[Upgrade to Revision]

R20TS1093EJ0100

e² studio RX Smart Configurator Plug-in 2025-01, Smart Configurator for RX V2.24.0

Outline

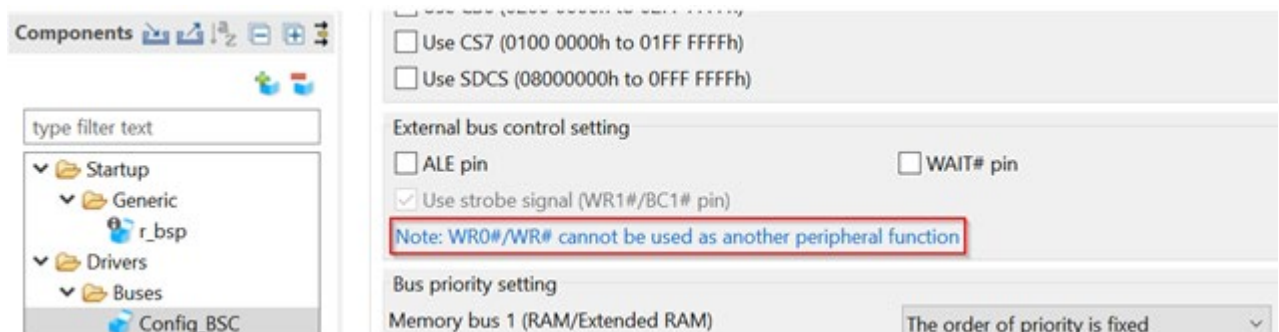
- Using Visual Studio Code with VS Code Debug Extension for Renesas GDB v25.2.1 or later, projects generated with the Smart Configurator can be easily built on VS Code using Ninja.

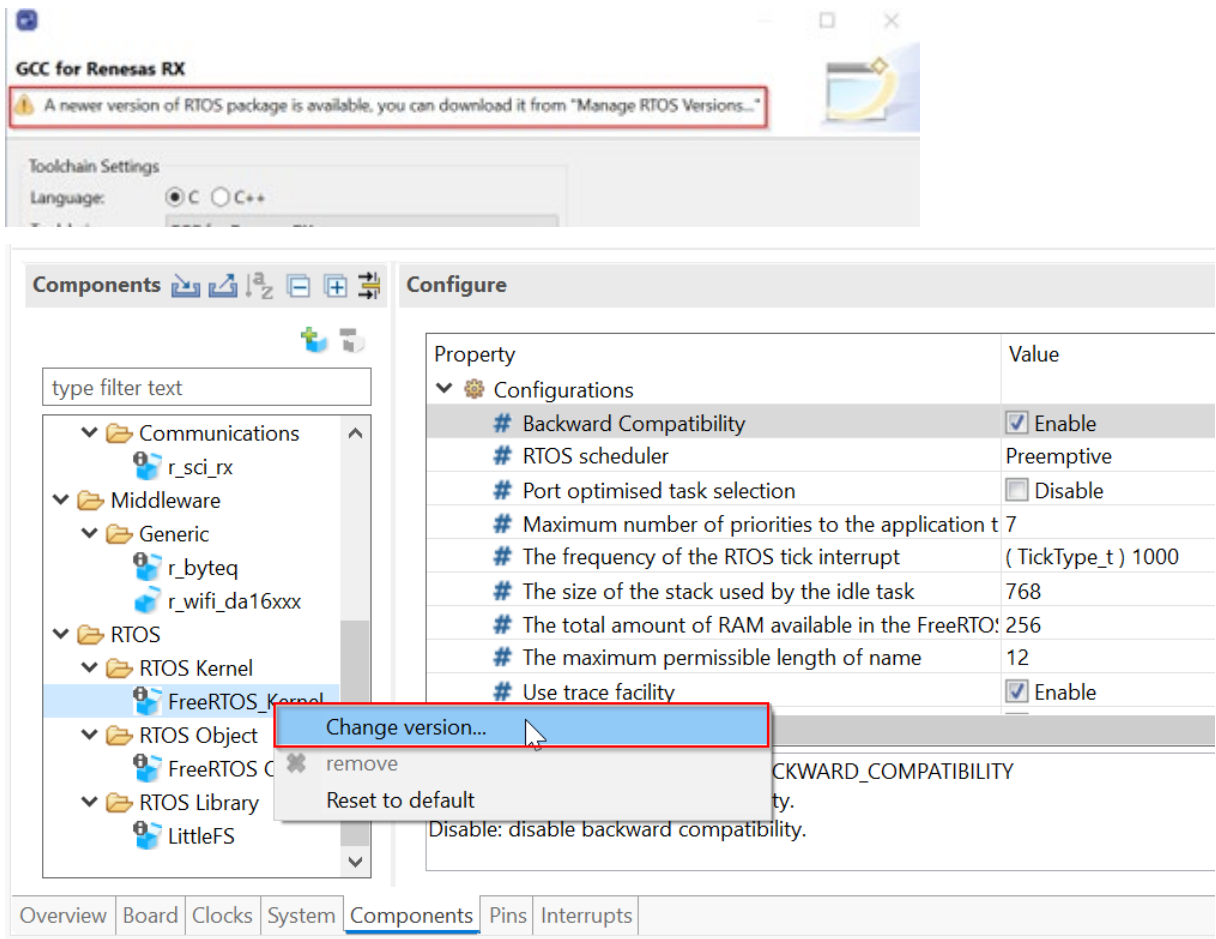
- When using the bus component, there is a warning message for WR# pin. Applicable devices: all RX600, RX700 devices, and RX230, RX231

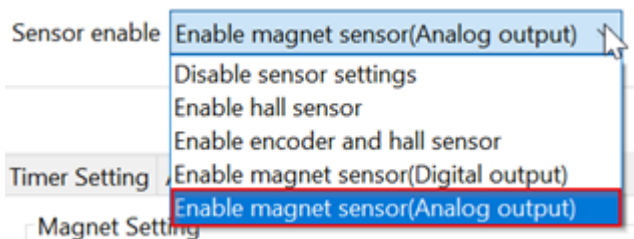
- From this version, the FreeRTOS package update information is displayed. In addition, the FreeRTOS version can be selected.

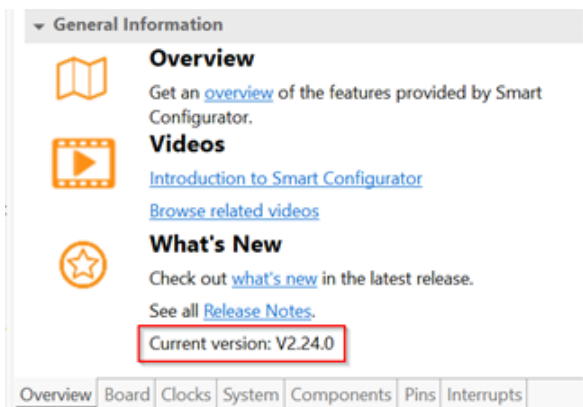
- Added magnet sensor (analog output) setting to the RX24T motor component.

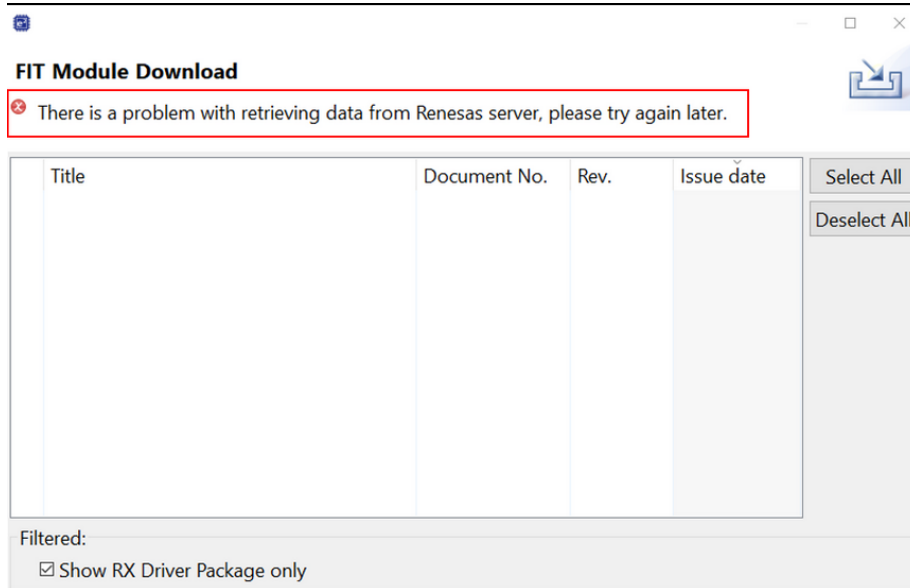
- Smart Configurator versions are displayed in the "Overview" tab.
